## **REMARKS**

Attorney Docket: 4041J0063CPA

**TRANSLATION RELATIVE TO THE PARTS OF FIGS. 11A-11D.**

**FIG. 11A** PRIOR ART

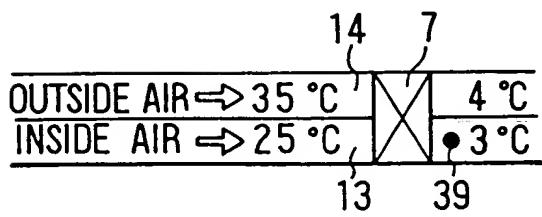
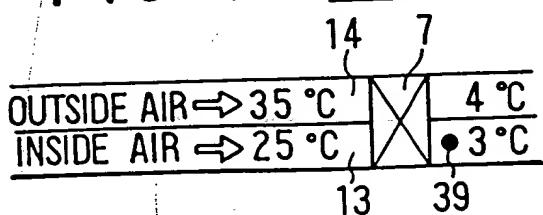
Claims 1, 3-8 and 10 are rejected under 35 U.S.C. § 103(a) as being unpatentable over prior art Figure 11C and Figure 11D in view of JA '411 or JA '831 or JA '426 and JA '645. The Examiner has based his rejection of Figures 11A-11D of the present application which are labeled "PRIOR ART". These Figures were mistakenly identified as prior art by the Applicants, when in fact, these drawings are the same as Figures 8a to 8d of JP8-152721 which is one of the priority documents for the parent application and the present application. Enclosed with this amendment is a copy of Figures 8c-8d and a translation of the portion of priority document JP8-152721 which relates to Figures 8a-8d of that priority application. As can be seen, Figures 8a-8d of the JP8-152721 are identical to Figures 11A-11D of the present application and the specification of the priority document is similar to that of the present application (page 5 of the translation and page 25 of the application). The present application has therefore been amended to remove the "PRIOR ART" designation for Figures 11A-11D.

**FIG. 11A ~~PRIOR ART~~**

**FIG. 11B** PRIOR ART

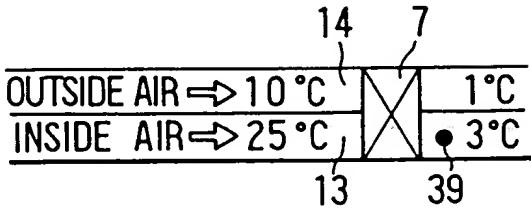
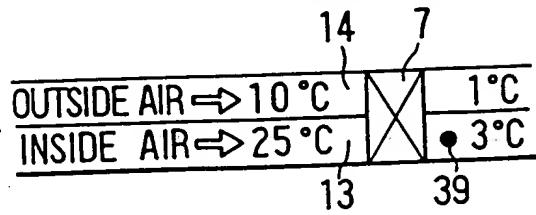
According to experiments of the inventors of the present invention, for example, when a temperature sensor is **simply** disposed in the first air passage (inside air passage) in the winter where the outside air temperature is lower than the inside air temperature, as shown in Figure 11B, the temperature of outside air blown from the evaporator (7) is lower than the temperature of inside air blown from the evaporator because the operation of the evaporator is controlled only based on the temperature of inside air from the evaporator. Therefore, in the winter, the cooling temperature of the evaporator may be lower than 0°C, and the evaporator may be frosted. For overcoming this problem, when a sensor set temperature is increased (e.g., from 3°C to 5°C), the temperature of outside air from the evaporator is increased to 7-8°C, and cooling performance and dehumidifying performance of the evaporator become insufficient. On the other hand, when the temperature sensor is **simply** disposed in the second air passage (outside air passage) as shown in Figures 11C and 11D, the same problem described above is caused because the operation of the evaporator is controlled only by the temperature of outside air from the evaporator. Thus, in the present invention, the set temperature of the temperature sensor (39) is changed in accordance with the outside air temperature. Accordingly, the feature of the present invention is completely different from that of each reference.

**FIG. 11B ~~PRIOR ART~~**
